# TEXAS DEPARTMENT OF TRANSPORTATION

## MINOR DESIGN UPDATES UNDER CONSIDERATION FOR FINAL DESIGN

## CROSS STREET IMPROVEMENTS

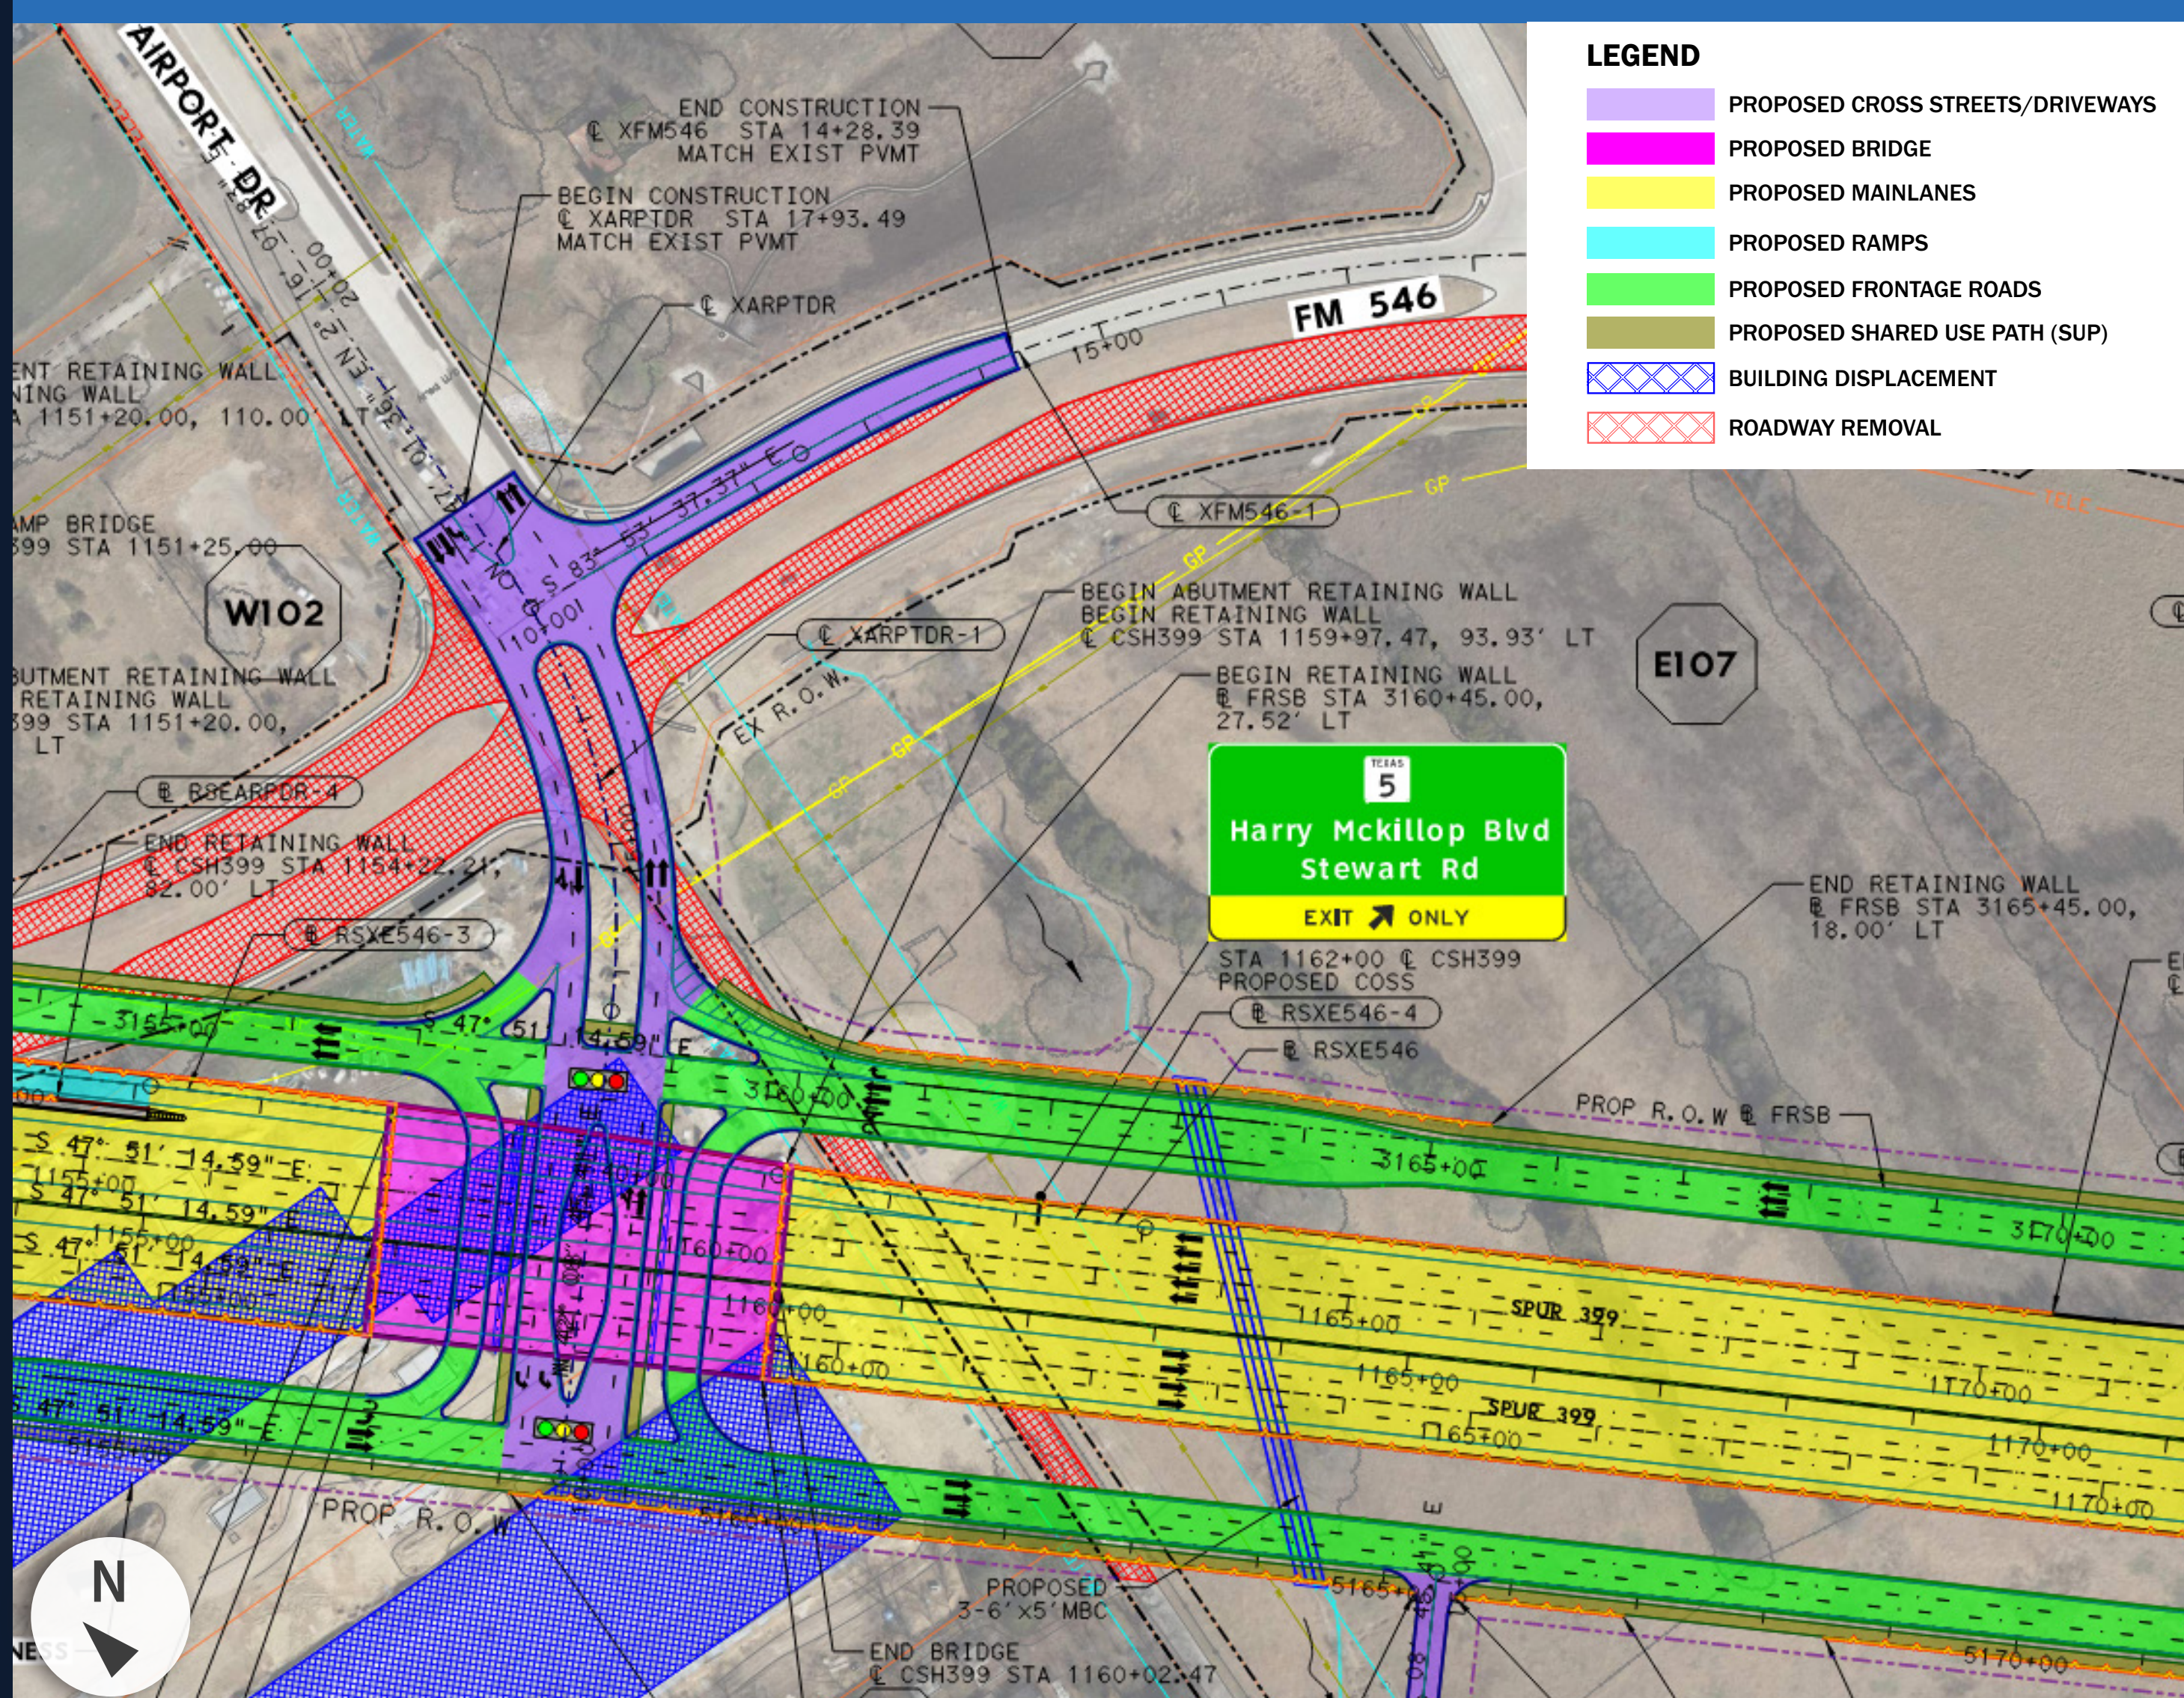
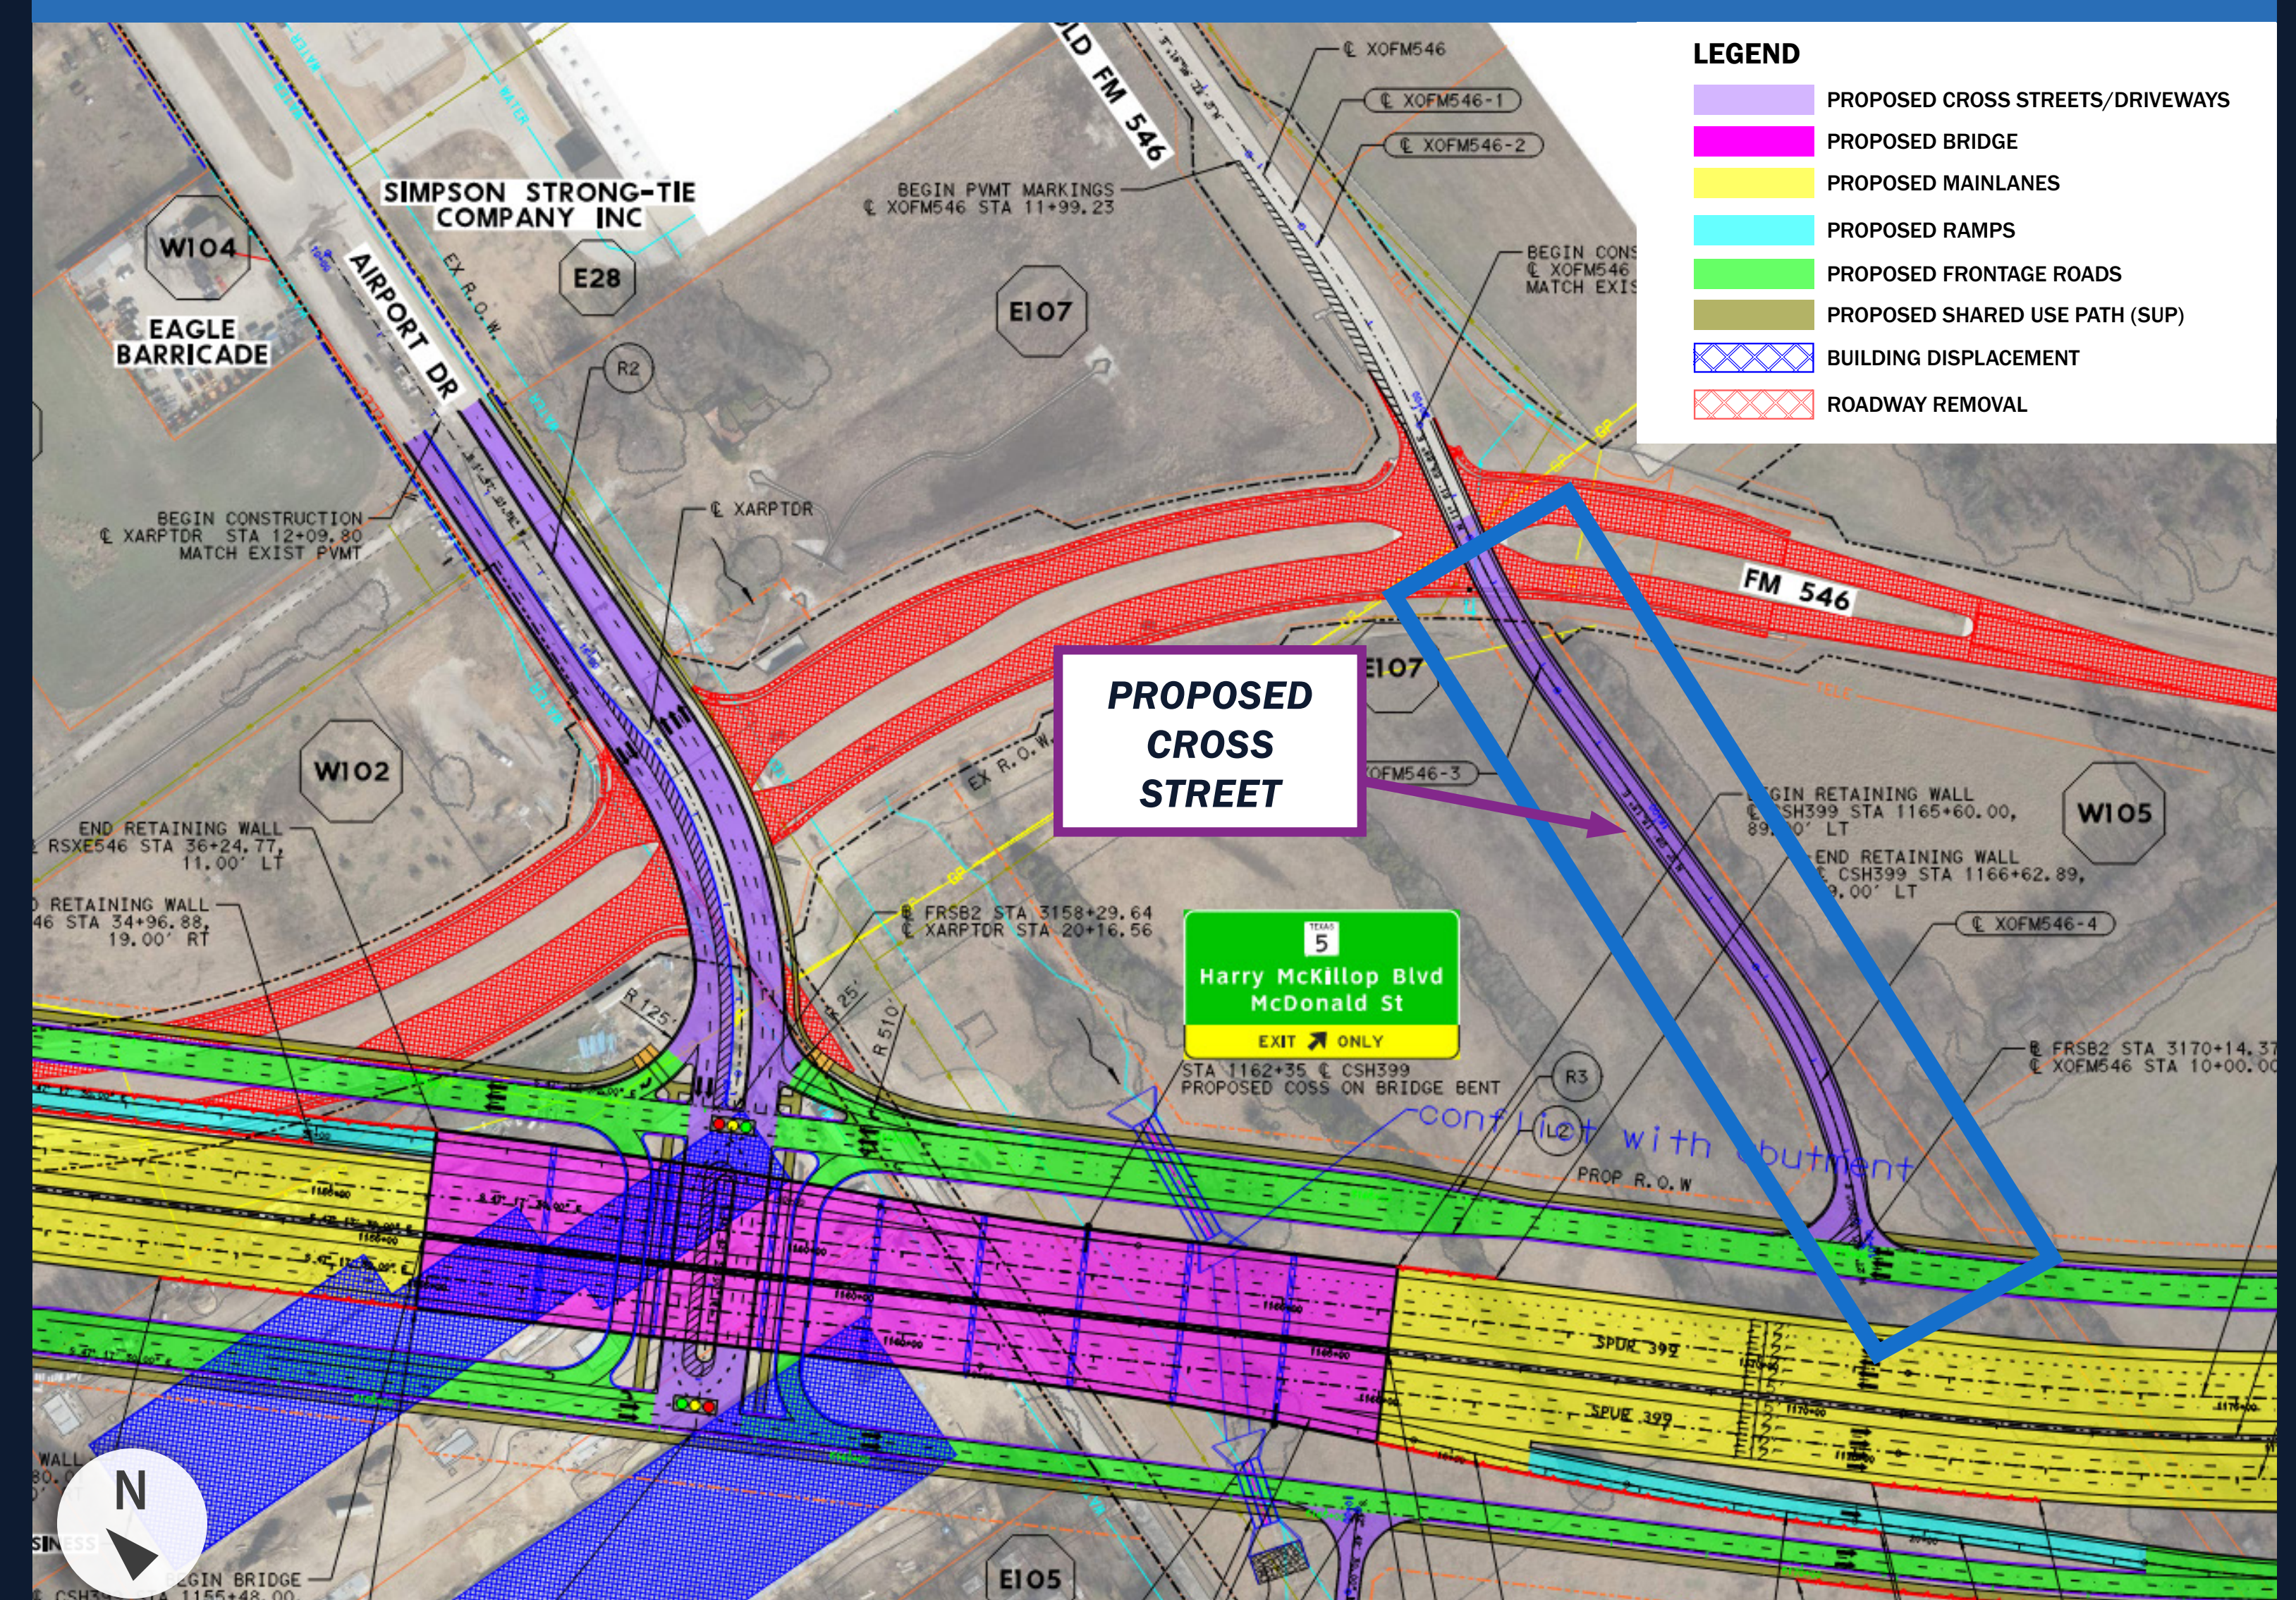
The proposed design would remove existing FM 546 and add a new cross street to connect Old FM 546 to the westbound frontage road. This will remove the need for a right-turn lane at Airport Drive.
